November 15, 2011 Mason Dam work session

November 15, 2011

Mason Dam Work Session

Figure 5-1. Dissolved Oxygen Levels at the Range of Mason Dam Intake Elevations. Based on 2007 Data.

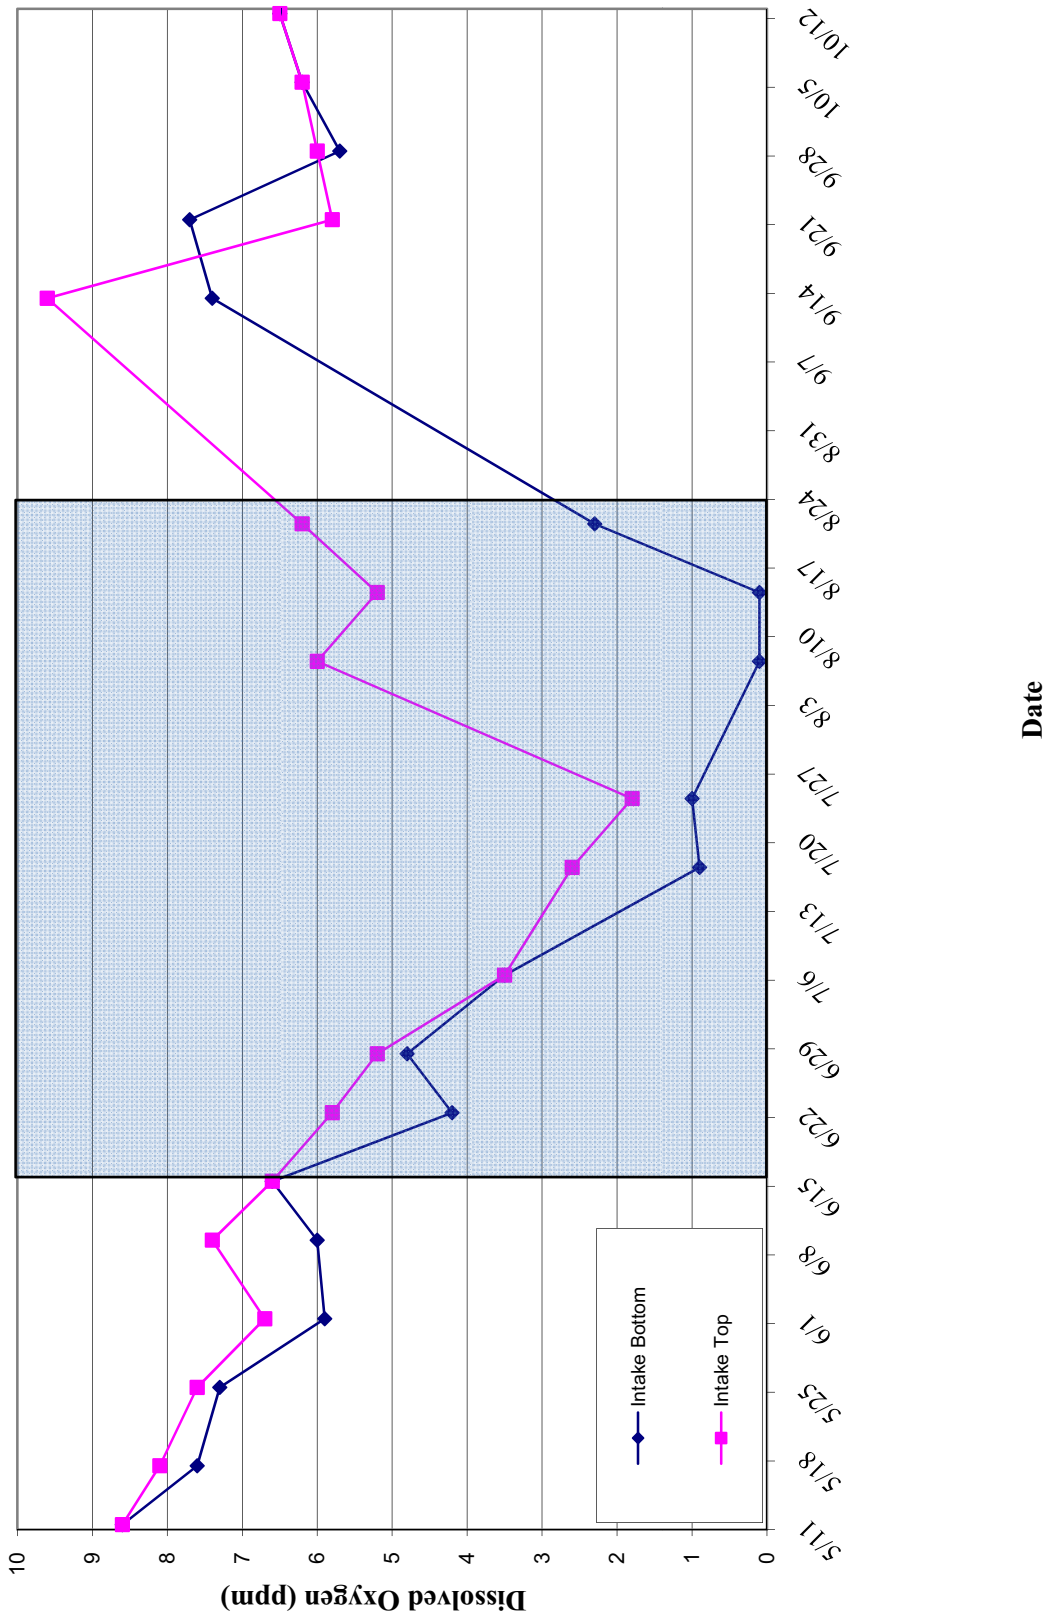
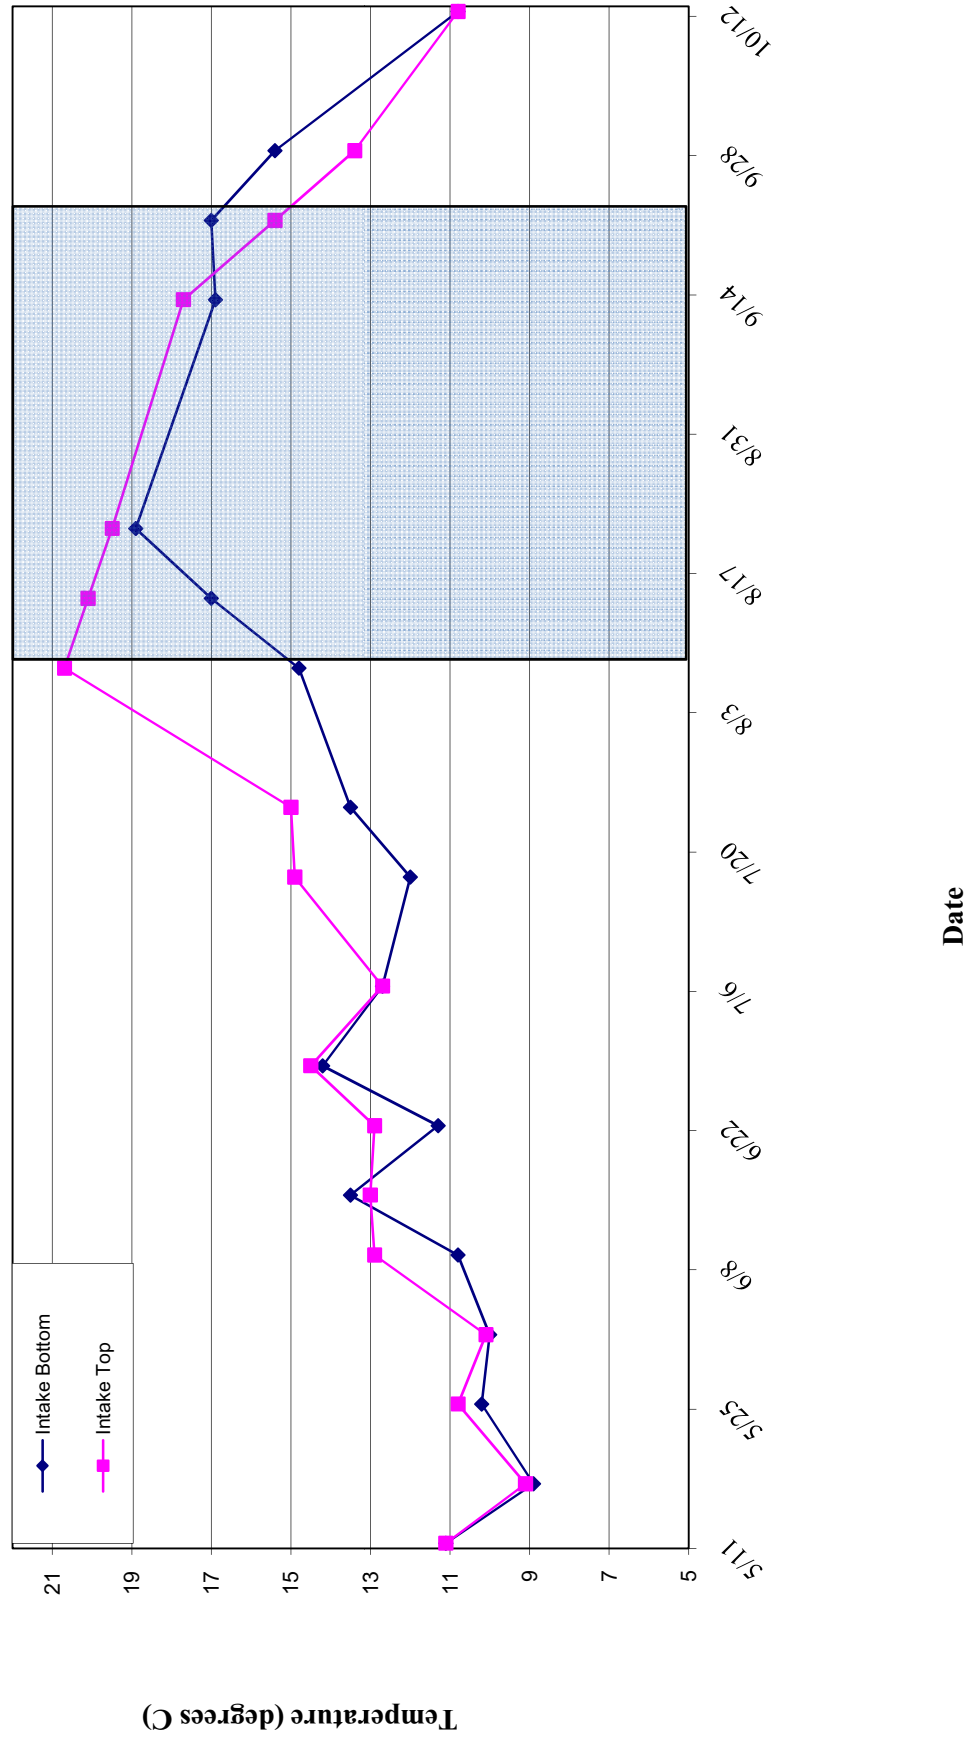
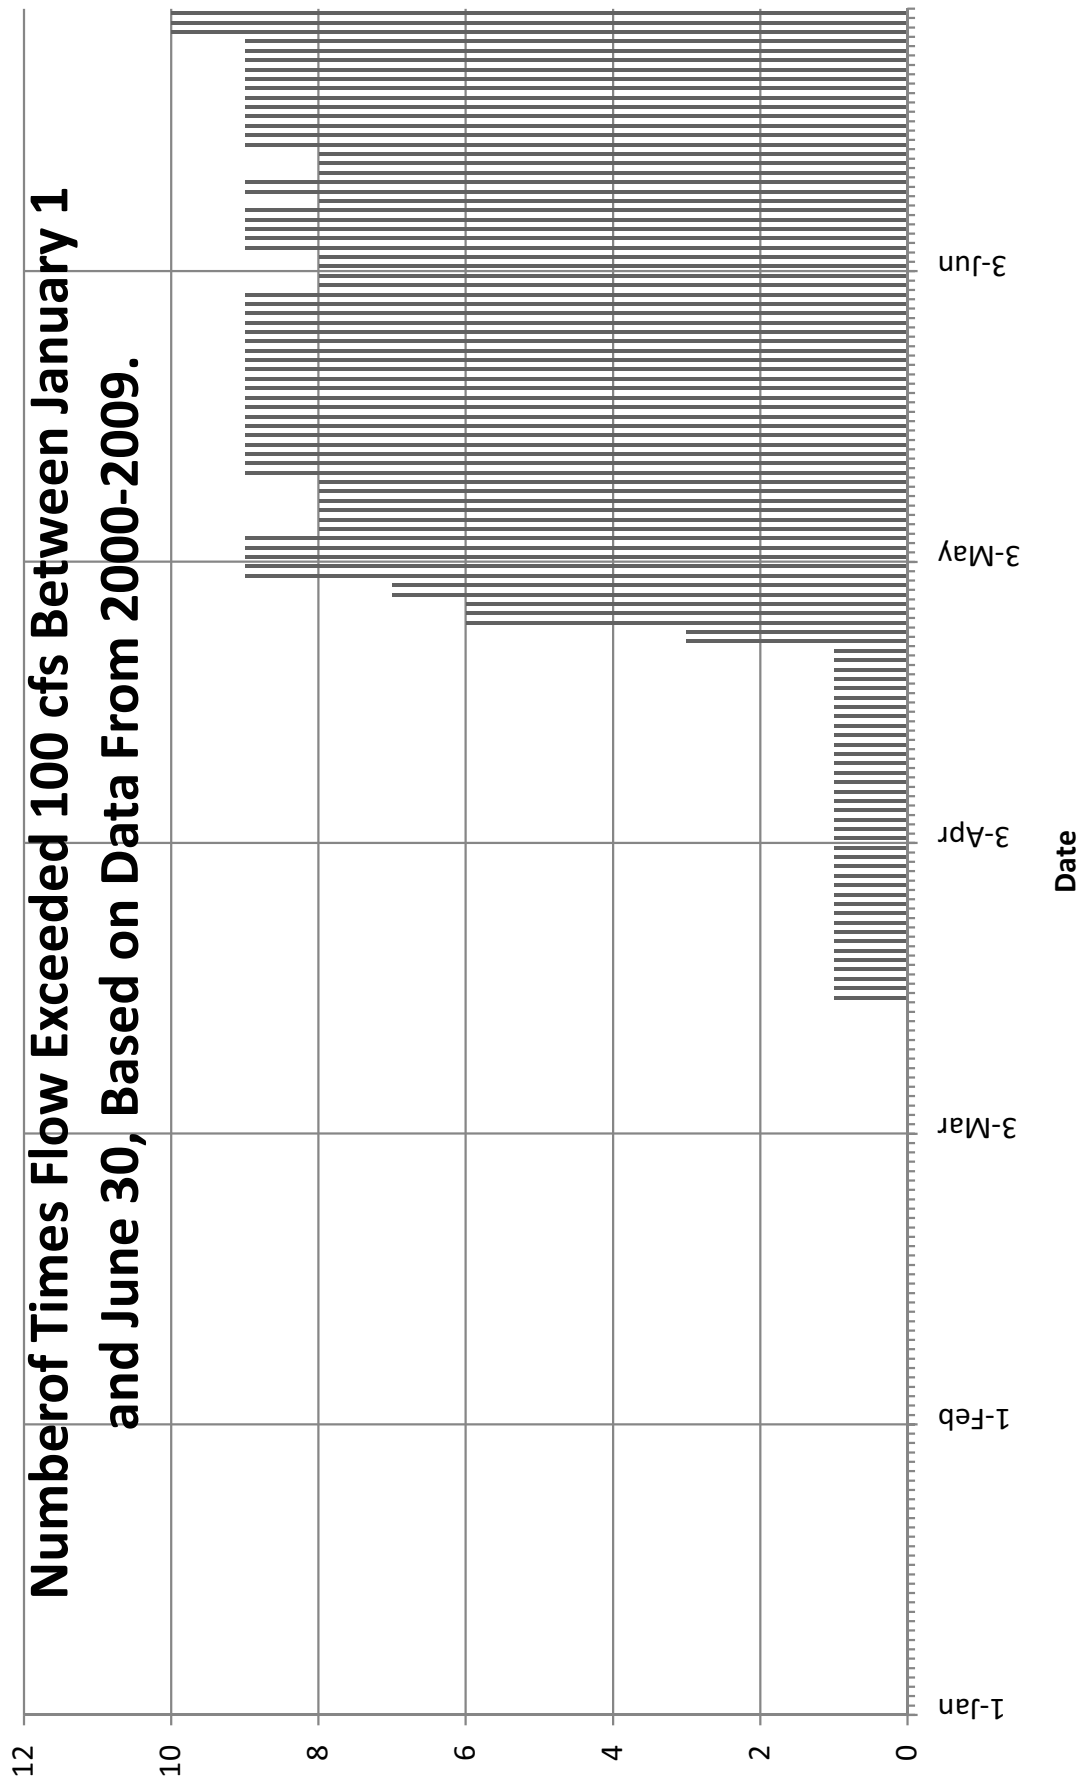
One of the things discussed in the DBA was the water quality and the effects on the bull trout particularly the stratification that occurs in Phillips Reservoir. Water quality monitoring was done near the Mason Dam intake. The data was looked at and compared to the life stages of bull trout, juvenile versus adult. Tracking studies that were also looked at which included: Flathead Reservoir, Beulah Reservoir, Lake Billy Chinook, and a couple others to look at the seasonal bull trout movement and how that compares to Phillips Reservoir. The question that we asked ourselves were, how would these movements correlate to the risk of entrainment in Phillips Reservoir? The project is not going to change the risk of entrainment but what will happen to the bull trout once entrained. In looking at the handouts provided (and included at the end of these minutes) Table 5-3 is a new water quality table that is different than the previous tables provided because the previous tables showed the bottom elevation of the intake and not the top. The new tables show the range of condition of temperature and DO from the top to the bottom of the intake. Beginning in the summer, DO conditions are outside bull trout

survival limits. The DO data is not broke into adult or juvenile numbers like the temperature columns, instead any DO below 6.5 would not be suitable for bull trout.

Colleen asked about how close were these measurements to the intake. Jason replied that the water samples were taken near the intake but a little to the Southwest of the intake so that the measurements could be taken of the full water column down to the old river channel which would be the deepest part of the reservoir. Colleen's concern was the horizontal distance of the samples to the intake as the DO could change.

Leslie continued, that in the other reservoir studies that if the reservoir stratifies, or not, because some of the reservoirs don't stratify as much and some of them do, come June the bull trout are moving. The moving starts based on temperature and photoperiod. Even when the reservoir does not stratify the bull trout start to move out of the deep area. There are two things occurring in all of the studies she has seen. One is that there is a pattern of bull trout life history moving out of deep water and the second is the water quality issue. So we are looking at the water quality of the intake and the assumption was made that the water samples are representative of the water at the intake. Figure 5-1 is a graphical representation of table 5-3 DO column and figure 5-2 is a graphical representation of temperature.
